**ADDRESS: 413 S 3RD ST**

Proposal: Demolish rear one-story addition; construct two-story addition

Review Requested: Review In Concept

**REPORT OF THE ARCHITECTURAL COMMITTEE  
OF THE PHILADELPHIA HISTORICAL COMMISSION**

PROPOSED SOUTH ELEVATION FACING STAMPER STREET

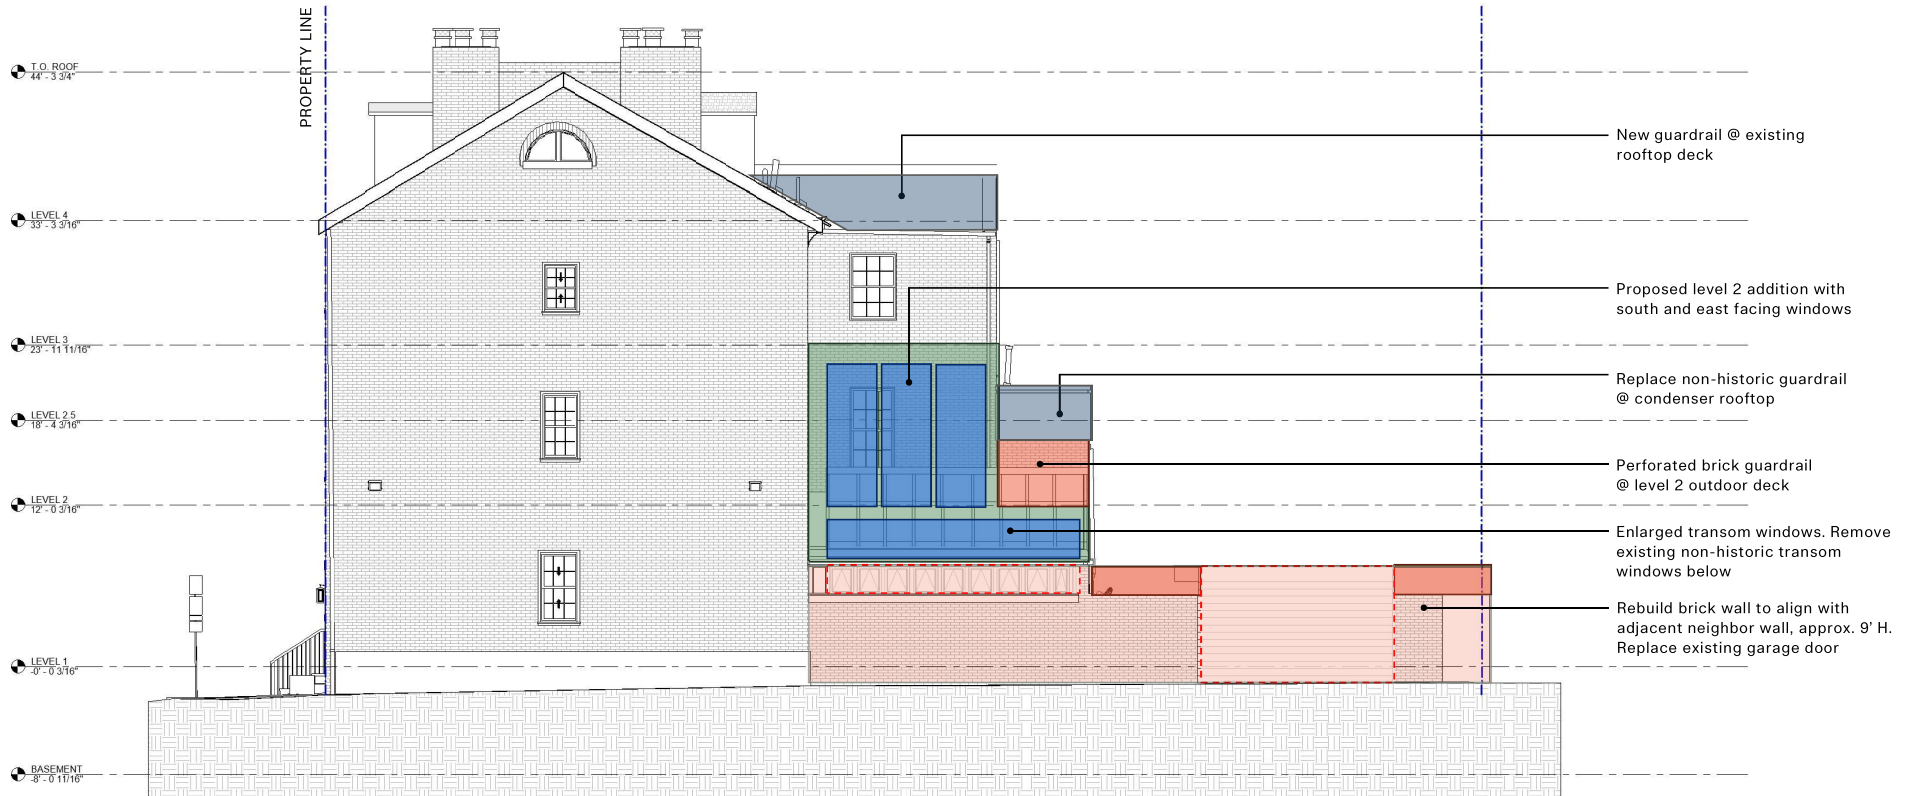
- Mr. Detwiler inquired about the proposed cladding material for the exterior walls. He observed it was represented by a green color in the renderings.

- Mr. Detwiler agreed with this proposed revision.
- Mr. Detwiler stated the proposed addition looked like a glass box minus the roof and noted there was not much wall shown. He recommended that there be more solid wall and less glass on the addition. Mr. Detwiler added that, at nighttime, it will read as a glowing box.

- Mr. Detwiler responded that he is fully in support of windows, but it is the proportion of windows to wall that is his concern. He said the design as presented has too much window and not enough wall surface.

- Mr. Detwiler said he wanted to discuss the long span of windows over the garden wall. He asked if they were extending the ceiling height of the rear room on the first floor. Mr. Detwiler commented that the row of windows appeared to be more of a contemporary design. He noted that he did not have a strong opposition to that personally.

- Mr. D'Alessandro remarked that the Architectural Committee was looking for compatibility with existing materials in the neighborhood.
- Mr. Detwiler recommended that the roof should be pitched away from the existing building.

- Ms. Litvin responded that they have not yet specified a cladding material but are open to the Architectural Committee's feedback on materials.
- Ms. Litvin stated that the staff's comment about setting back the addition from rear corner of the historic building along Stamper Street was a design change that they had already been considering. She agreed this would be a good way to differentiate between the old volume and the new.

- Ms. Litvin said that adding larger windows to the addition was based on concerns that the historic main block does not get a lot of light and air movement along Stamper Street. She noted that they understand the design of the addition must be compatible with the historic building, but they are also trying to bring more natural light and air through its volume.

- Ms. Litvin confirmed that the ceiling height of the first-floor addition would be lower than the conservatory roof. She pointed out that there is already a strip of windows existing in this location.

- The proposed scale, proportion, and massing could satisfy Standard 9 if the proposed addition was set in slightly from the outer corner of the main block of the building. The design's fenestrations and materials should be more visually compatible with the historic building and environment to satisfy Standard 9.
